American National Standards

BSR/ASHRAE Addendum 62.1f-201x, Ventilation for Acceptable Indoor Air Quality (addenda to ANSI/ASHRAE Standard 62.1-2016)

FIGURE B2-1 Exhaust air discharge velocity (U).

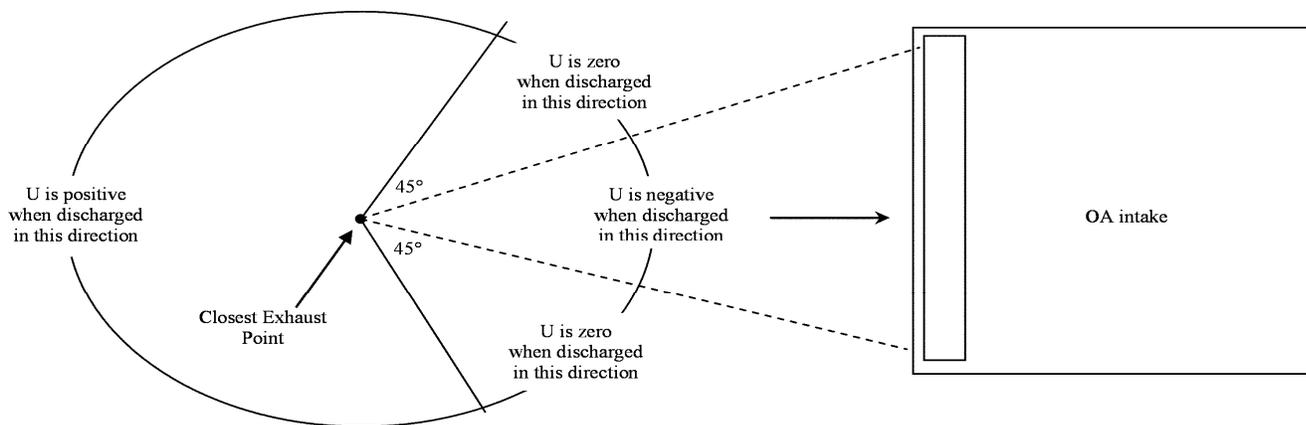
This proposed addendum makes several changes in Section 5. For outdoor air intakes, the alternate methods of calculation are specified in Normative Appendix B (Separation of Exhaust Outlets and Outdoor Air Intakes) and the exception is eliminated. Requirements that were in the notes of Table 5.5.1 are relocated to the body of the standard. If condensation is to be managed (Exception 5.14.2), then a management plan must be developed. If "local practice" demonstrates condensation does not grow mold, it can be included in the management plan. Table 5.16.1 (Airstreams or Sources) is relocated to Section 6 where all other air class information resides.

U = exhaust air discharge velocity, fpm (m/s). As shown in Figure B2-1, U shall be determined using Table B2-3.

Figure A.1

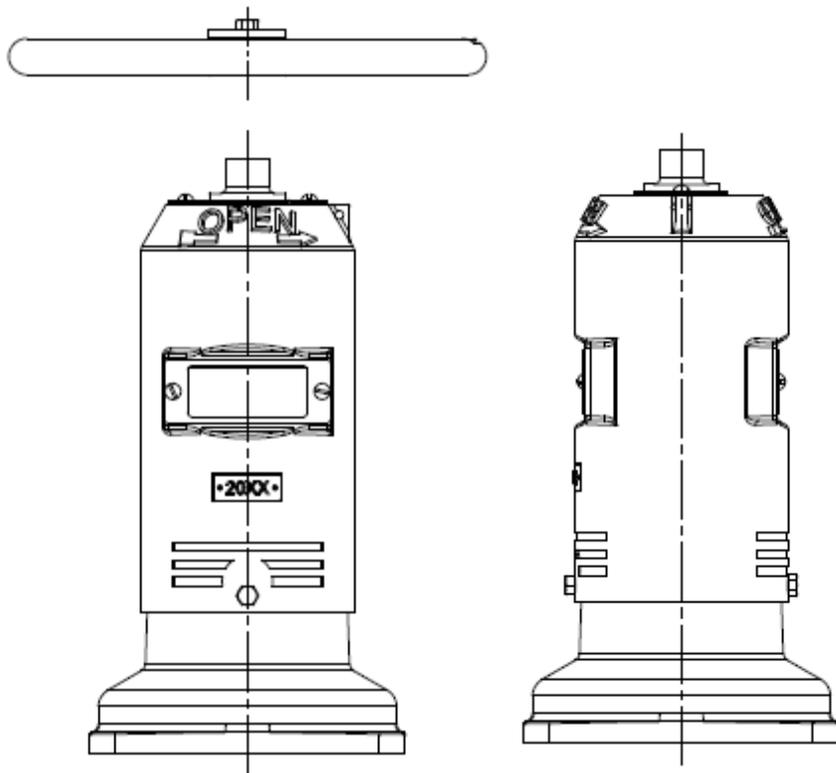
(1) Revised requirements to above ground valve mounted indicator post.

Please see supporting documentation in the CSDS Work Area for proposed figure A.1
